Part I. Proposal for amendments to Regulation No. 79 (Steering equipment) based on informal document GRRF-86-13

The text reproduced below was prepared by the expert from France introducing an amendment to UN Regulation No. 79 based on informal document GRRF-86-13.

Part II. Proposal for amendments to Regulation No. 79 (Steering equipment).

Annex 8: 2.4. Lateral acceleration

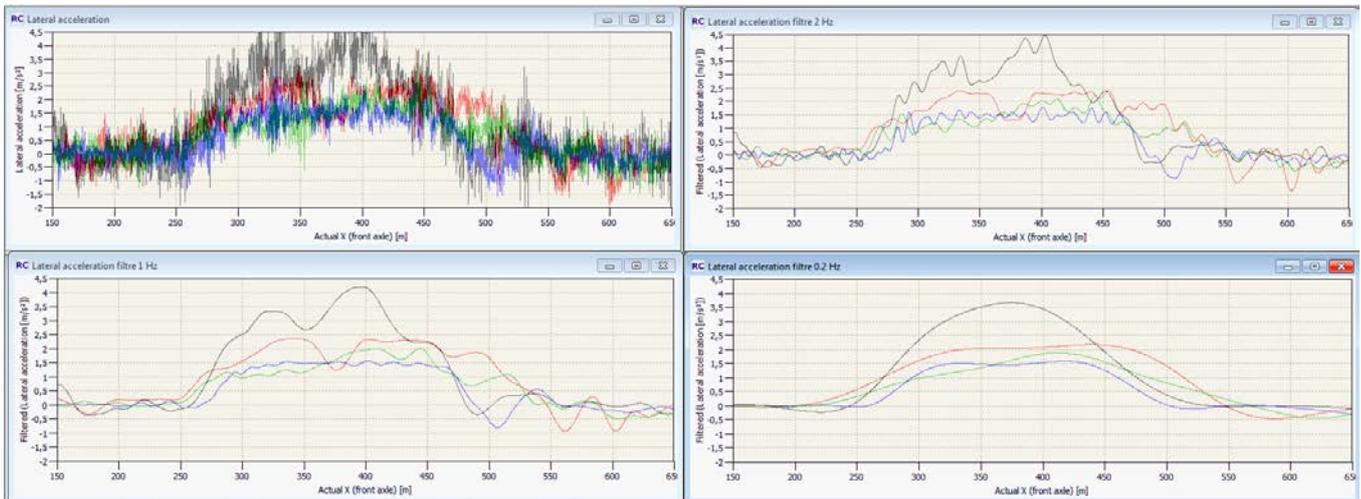
- For keeping a traceability, it could be interesting to indicate in the report both the position at which the lateral acceleration was measured and the position of the centre of gravity of the vehicle
- For dynamical tests the usual value of sampling rate is at least 100 Hz
- The figures below show the shapes of the lateral acceleration signals versus the value of the cut-off frequency: No filter, filter at 2Hz, filter at 1 Hz and filter at 0.2 Hz. The results show that the best representation of the dynamical behavior is obtained when the used filter is 1Hz.

“Lateral Acceleration Filtering”: Comparison of tests led on 4 vehicles in the same curve.

- **Figure 1: raw data (no filtered)**
- **Figure 2: Signal filtered at 2Hz**
- **Figure 3 : Signal filtered at 1Hz**
- **Figure 4 : Signal filtered at 0,2hz.**

To determine the lateral acceleration, the raw data shall be filtered by applying a 4th order Butterworth filter with a cut-off frequency of ~~0.2 Hz~~ 1Hz.

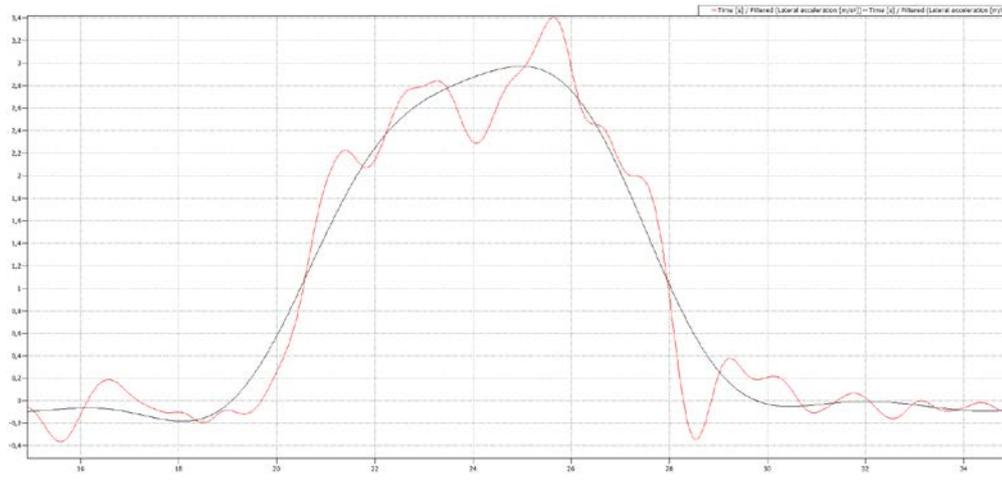
Figure “Lateral Acceleration Filtering”: Comparison between the 2 proposals for a vehicle near the limits: blue line (0.2hz) as proposed in document GRRF 86-13 and red line (1 Hz) as proposed in this document. In the first case the vehicle passes the test (Maximum value: 3m/s²) while in the second case the vehicle fails the test (maximum value: 3,4m/s²).
